Jan. 12th, 2022

Copper Value Housing Appearance Change Notification

The photos below use MGD 2/2 valve as example.

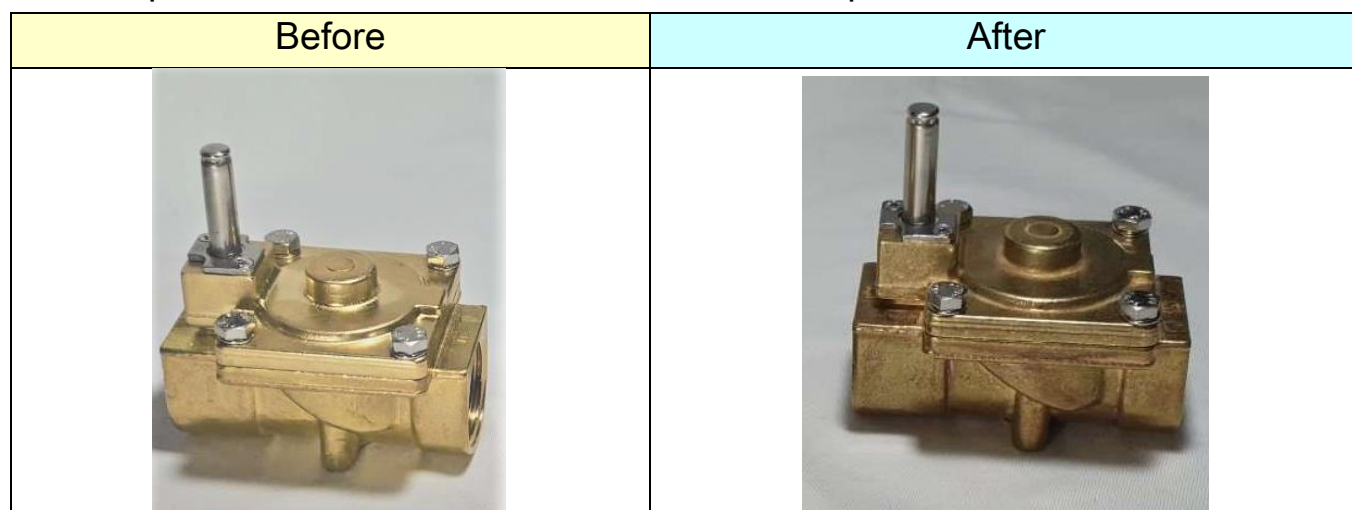
The appearance of copper housing will be darker than before.
